Application for Certification for the  
Hidden Hills Solar Electric Generating  
System

Docket No. 11-AFC-02

**HIDDEN HILLS SOLAR ELECTRIC GENERATING SYSTEM**  
**STATUS REPORT #1**

**Alternative Traffic Route for the Proposed  
Hidden Hills Solar Electric Generating Station**

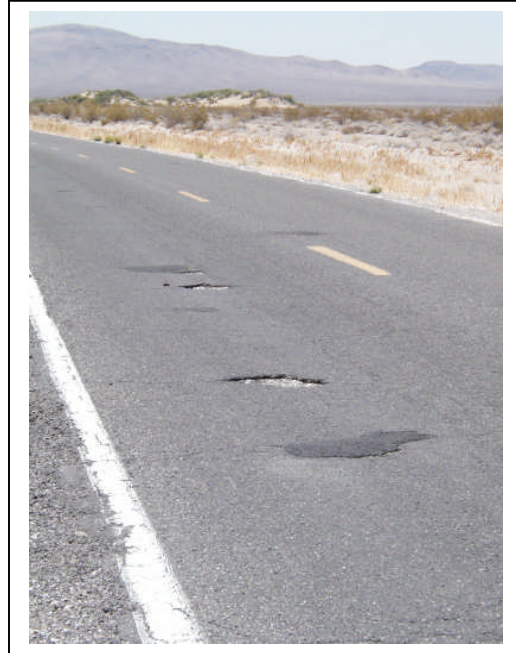
Finally, it has been repeatedly acknowledged that the current condition of the Old Spanish Trail Highway fails to qualify as a functional infrastructure component necessary to support the proposed project, regardless of whether assessing the Nevada or California side of the road. Below are photos of the Old Spanish Trail Highway’s current pavement condition.

On left, Old Spanish Trail Highway looking East between Charleston View and St. Theresa Mission directly adjacent to the proposed project site. Above, recent road repair slightly West of St. Theresa Mission. 5/17/12

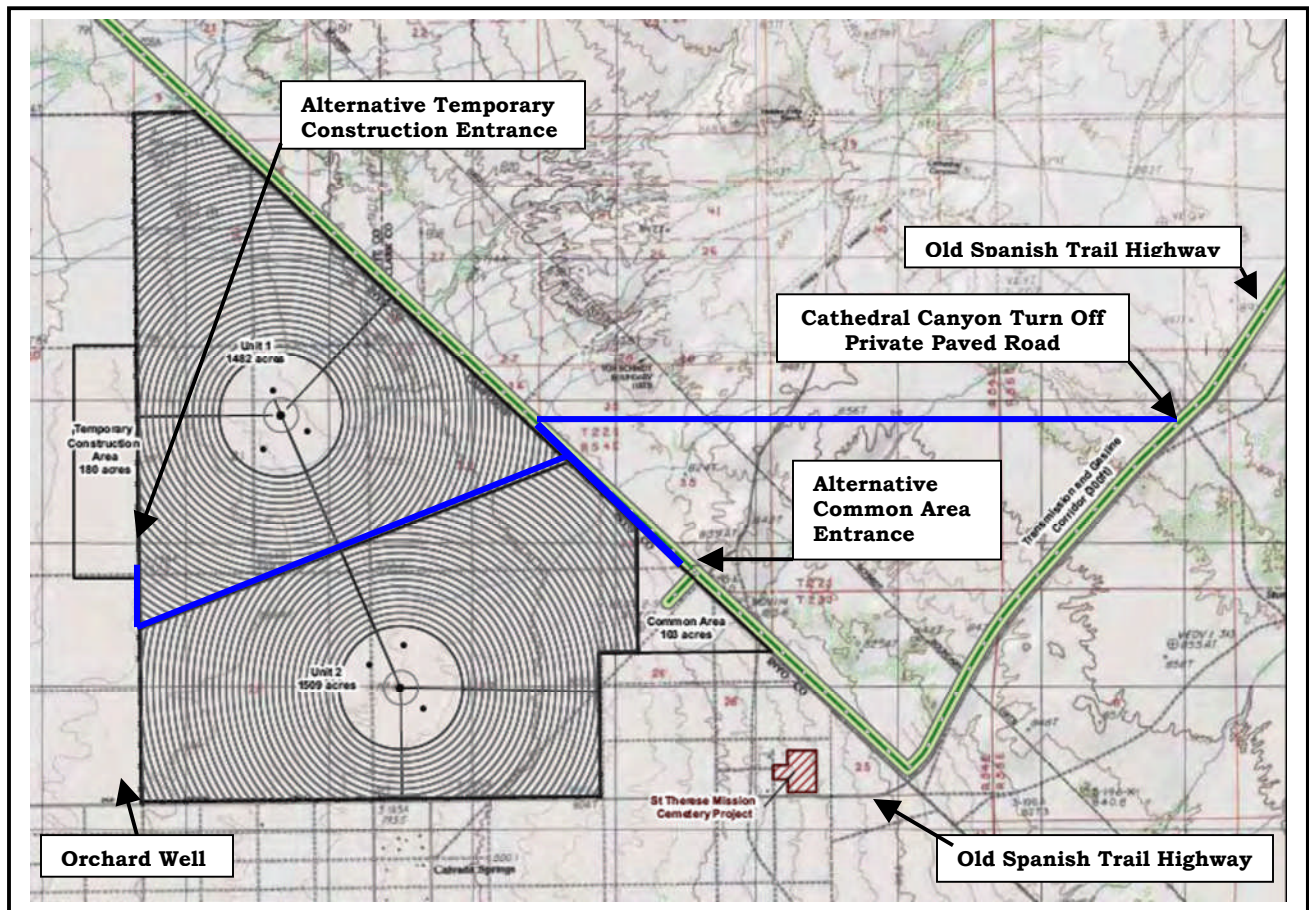
Instead of project traffic entering the site from the Old Spanish Trail Highway on the California side of the border, entry could also be obtained on the Nevada side of the Old Spanish Trail Highway at the juncture of a private road formerly used to access Cathedral Canyon. This road (shown right) is located 5.5 miles from Orchard Well and while not complete, could be developed to lead directly into the project site.

The road is owned and controlled by the same parties who are leasing the land to applicant and therefore, they have complete control to authorize the construction and maintenance of a private road to access the site.
